Market Lane Park

Improvements

What We Heard Report #2

January 2022

Option 1, The Stitch - 49% 4 stars or higher

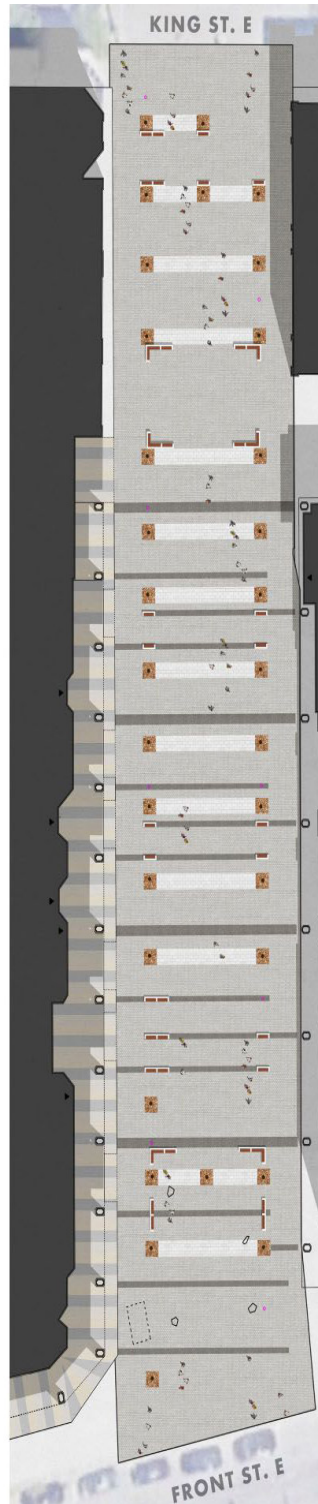
- *This option best references the areas historic significance*
- *Tying this small park into the surrounding area helps make the entire neighbourhood more interesting*
- *Noise is problematic granted the Park’s proximity to residential buildings*
- *Indigenous communities should be celebrated*
- *Love the simplicity of this design*
- *More should be done to make this space more engaging*
- *Flexible seating is desirable*
- *Maintain existing trees and add more greenery*
- *The water feature is great for children*

Option 2, The Flex - 32% 4 stars or higher

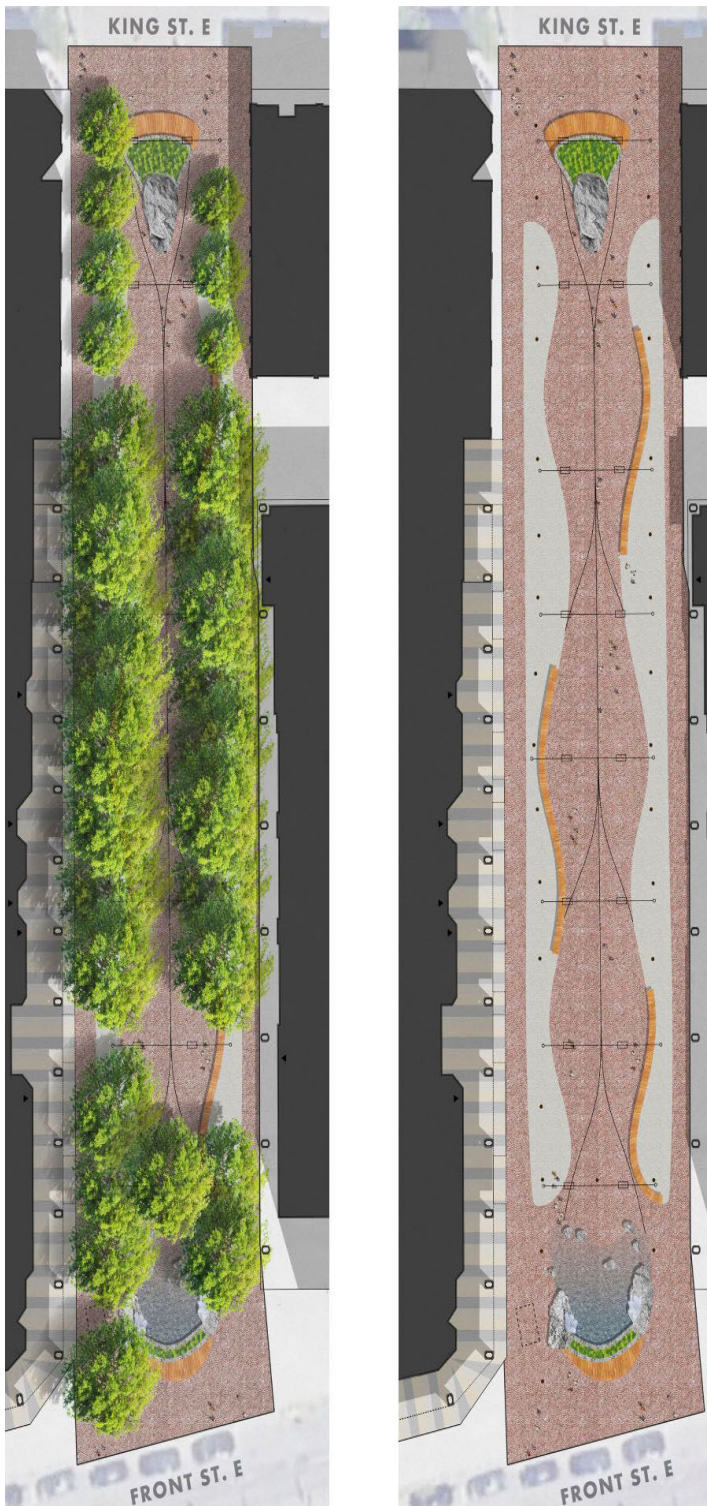
- *There are too many moving parts, would impede movement through the Park*
- *Who will maintain and reconfigure the moving parts?*
- *Covered seating is desirable*
- *The outdoor amenities make public health and hygiene more accessible*
- *Be considerate of people living adjacent to the Park*
- *I like the emphasis on flexibility to accommodate how people may choose to use this space*
- *Ensure that Indigenous programming has space*
- *This design seems stale and rigid*
- *Ensure the Park is well lit*

Option 3, The Meander - 68% 4 stars or higher

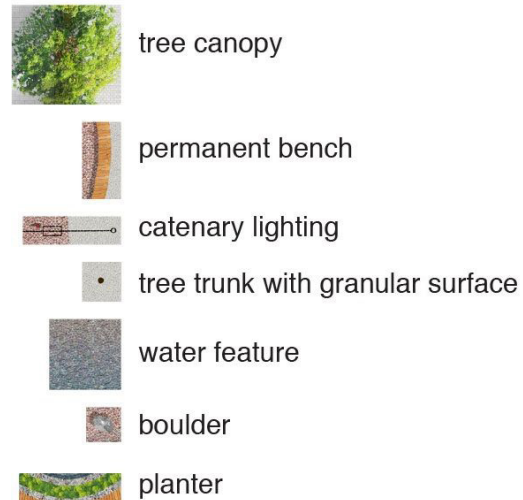
- *Love the non-linear design and focus on nature*
- *The water features need to be maintained so they do not accumulate litter*
- *The boulder seating may not be accessible to seniors*
- *Permeable groundcover should be incorporated into all design concepts*
- *The catenary lighting is nice*
- *More flexible seating*
- *Clear sightlines through the Park should be maintained*
- *Overall the most thoughtful design*
- *Sounds beautiful and peaceful*

Furniture and Lighting

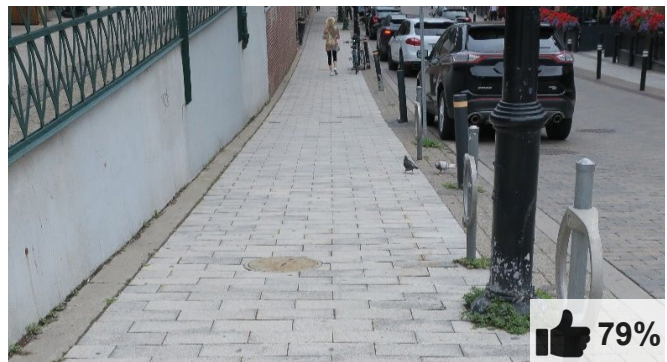
- *Moving furniture makes too much noise*
- *Seating for eating would be great in the vicinity of St. Lawrence Market*
- *Maintain the historic character of the neighbourhood*
- *Lighting should make the space safe and welcoming*

Water Feature

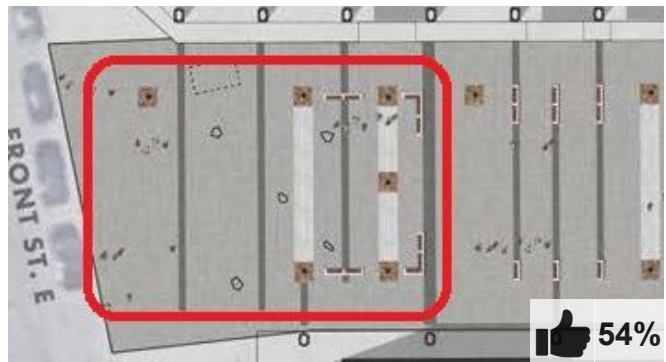
- *Feels out of place, does not maintain historic character*
- *Too difficult to maintain*
- *Great for the summer time*
- *A drinking fountain and hand washing station would be great*

Furniture and Lighting

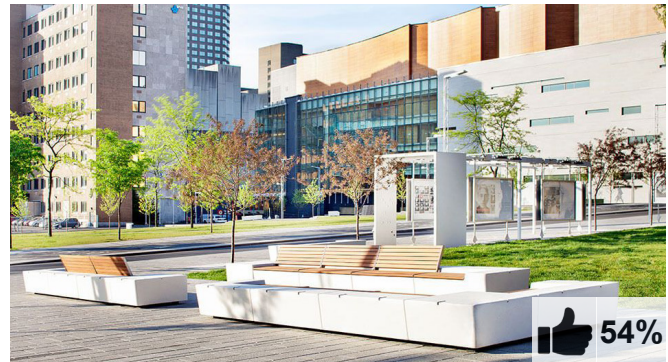
- *The benches look too obstructive and uncomfortable*
- *Design does not keep neighbourhood identity*
- *This space is not appropriate for markets, keep it natural*

Paving

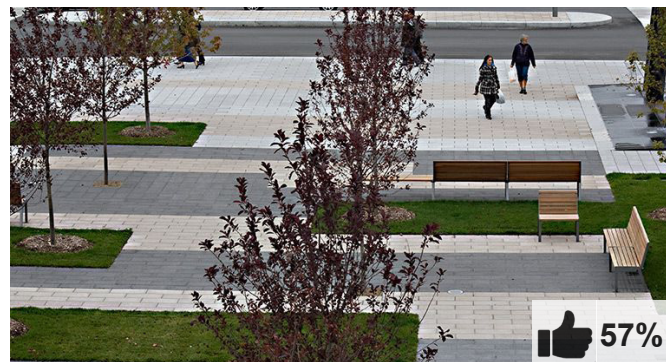
- *Too disjointed; does not match surrounding character*
- *Nice to see some color*
- *Lengthwise bands are preferable*

Water Feature

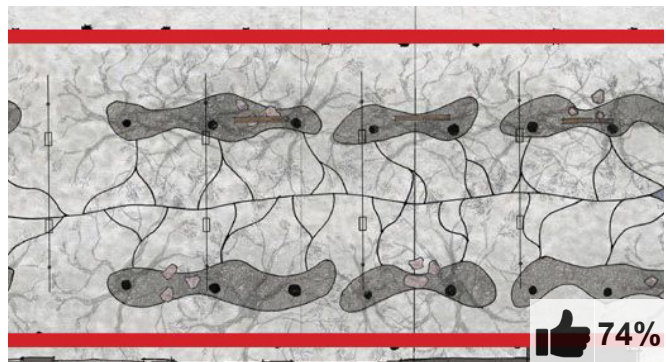
- *The boulders create too much clutter impeding pedestrian movement*
- *Great idea, but must be kept free of litter*
- *It's important to highlight the site's history*
- *Beautiful and memorable*

Planting

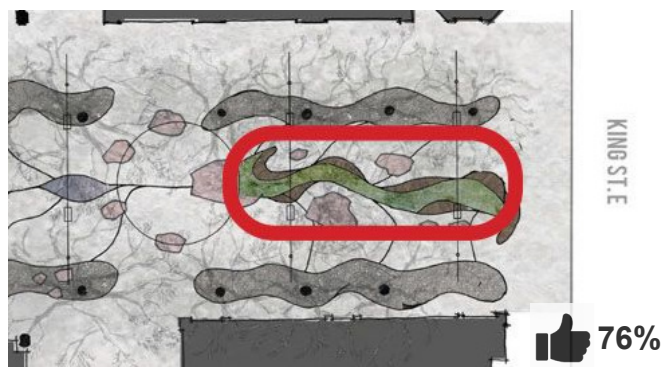
- *I like the idea of including native species plantings*
- *Sight lines across the Parks should be maintained*
- *This element should be included along with the existing trees*
- *Must be maintained and kept free of litter*

Paving

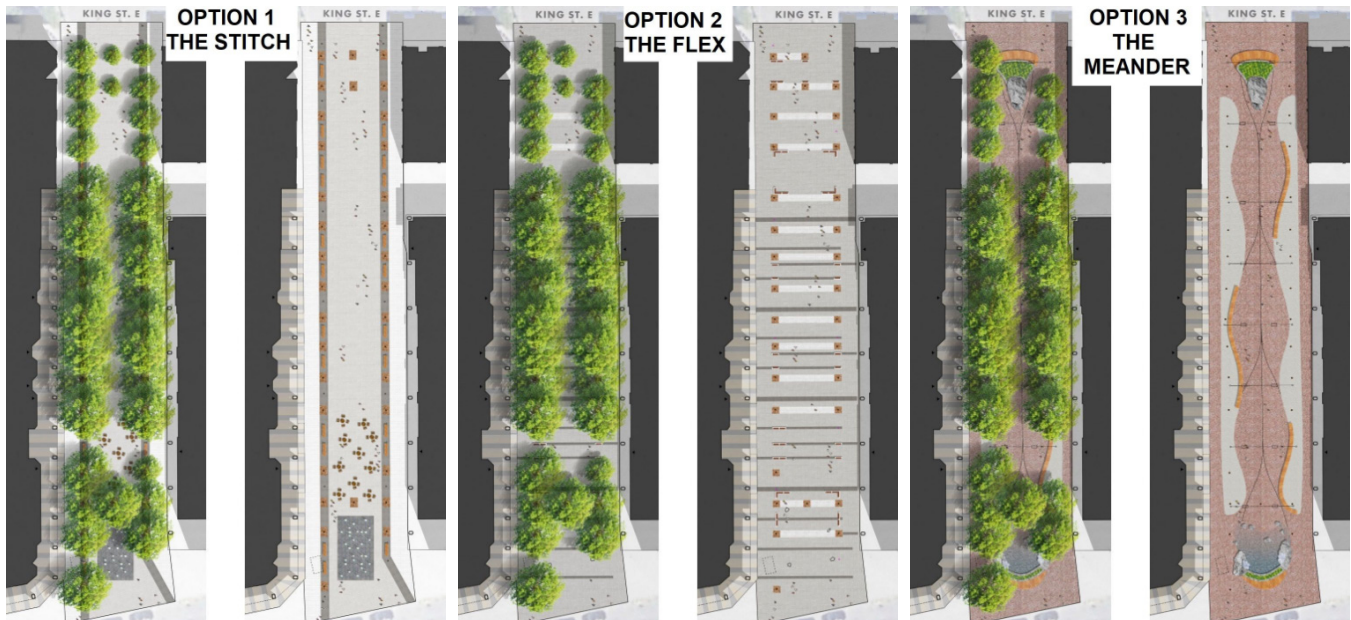
- *Nice design, ensure there are no trip hazards*
- *May be too difficult to maintain and keep free of litter*
- *Environmentally friendly and practical*
- *Paving elements add visual interest*
